APPLICATION FOR MODIFICATION OF

GENERATION LICENSE NO.IGSPL/05/2006 DATED JUNE 06, 2006 ON BEHALF

SAPPHIRE ELECTRIC COMPANY LIMITED (SECL}

Subject: Application for Modification of Generation License for Sapphire Electric Company Limited under Regulation 10 of the NEPRA Licensing (Application, Modification, Extension & Cancellation) Procedure Regulations, 2021

Annex-01:

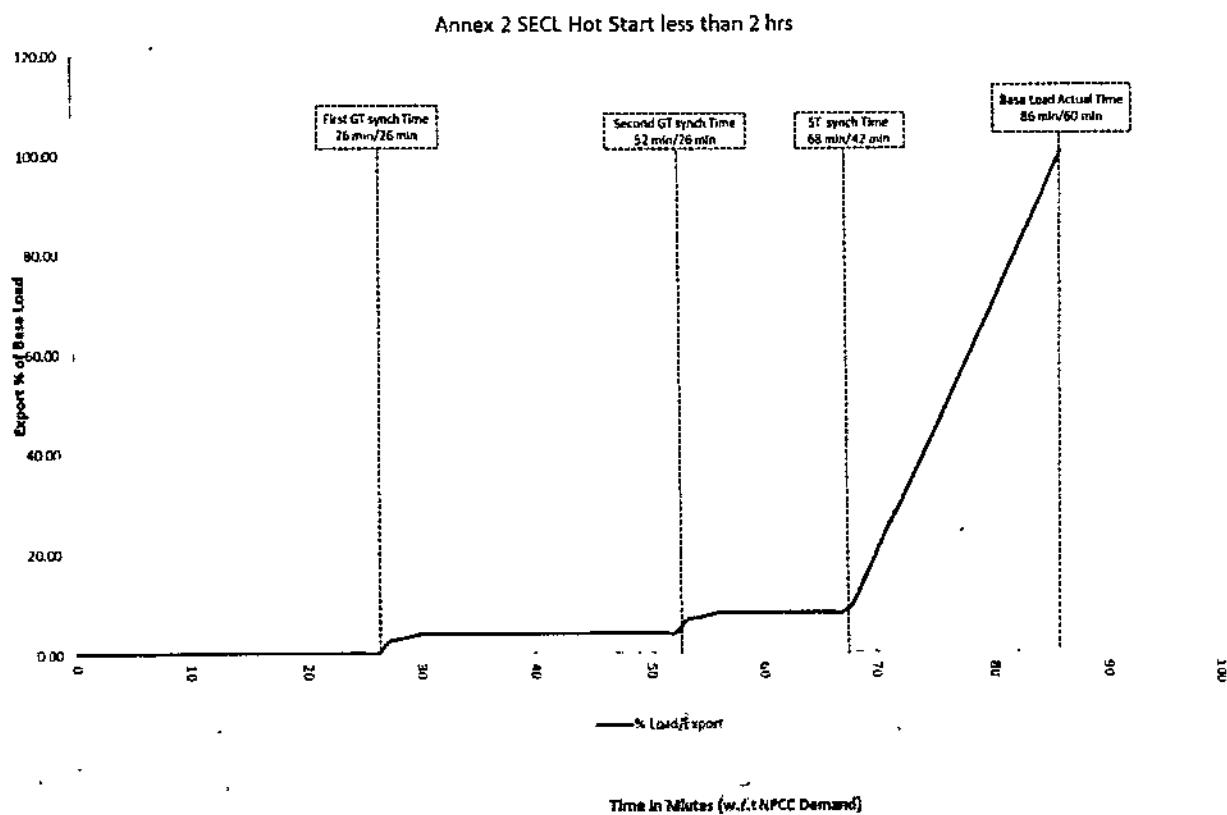
Based on OEM Start-Up Timetable and HRSG Preservation Requirements (Annex-1, GE Start-Up Table)

SECL Complex Startup (the following revised synchronization times are proposed):

Length of Shutdown	Notice required synchronizing				Complex Full Load (Minutes) after 1 st GT Sync
	Removal of HRSG Preservation (Minutes)	1st GT Sync after Removal of HRSG Preservation (Minutes)	2nd GT Sync after Sync of 1st GT (Minutes)	ST Sync (Minutes) after 1 st GT Sync	
i Not more than 2 hours	0	26	26	42	60
ii More than 2 hours but less than 8 hours	0	26	26	52	70
iii More than 8 hours but less than 32 hours	0	31	31	80	155
iv More than 32 hours but less than 150 hours	20	31	31	90	165
v More than 150 hours	20	36	36	130	320

Annex-3 SECL Hot Start 2-8 Hrs

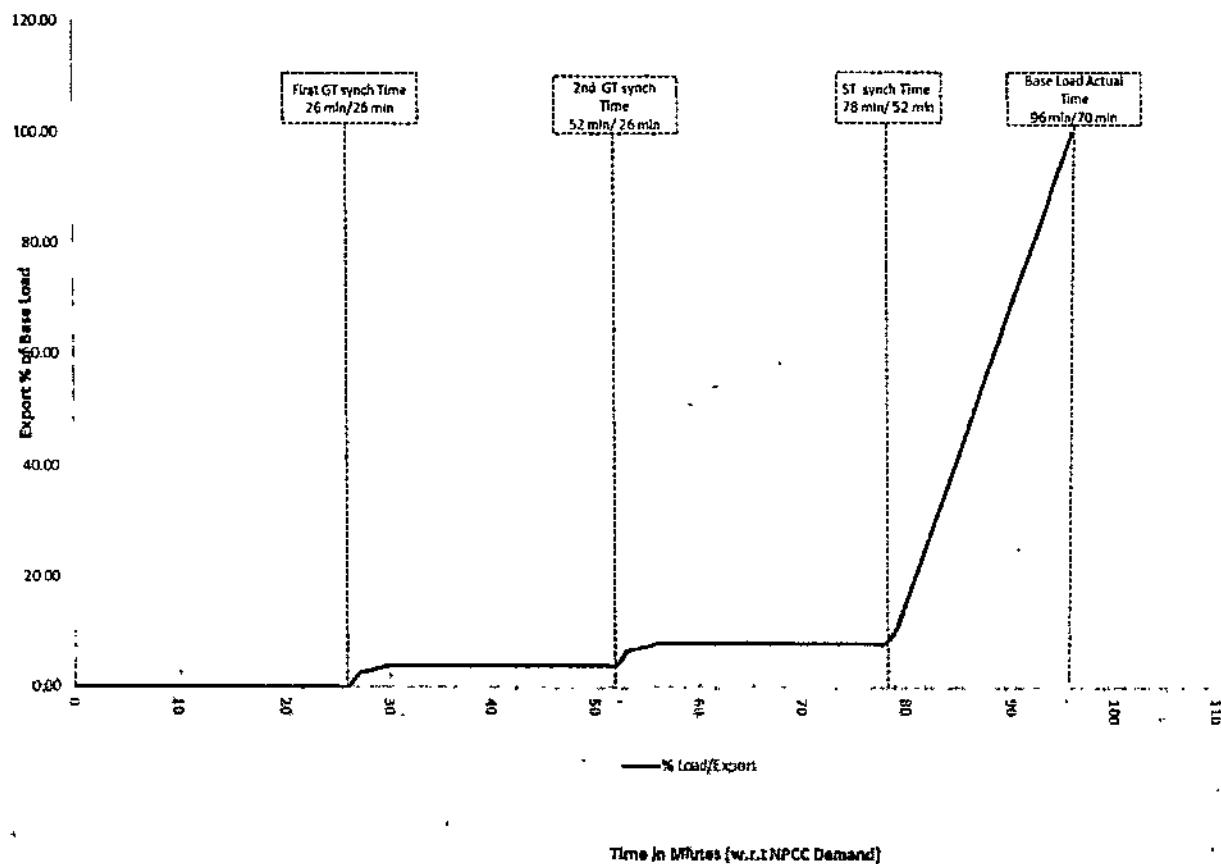
Given these considerations and historical operational patterns, we have made necessary clarifications in the Complex Start-Up Timetable, which is attached as Annexure-1. We have also included real-time data charts illustrating start-ups under various modes as Annexures-2 to 6 for your reference.
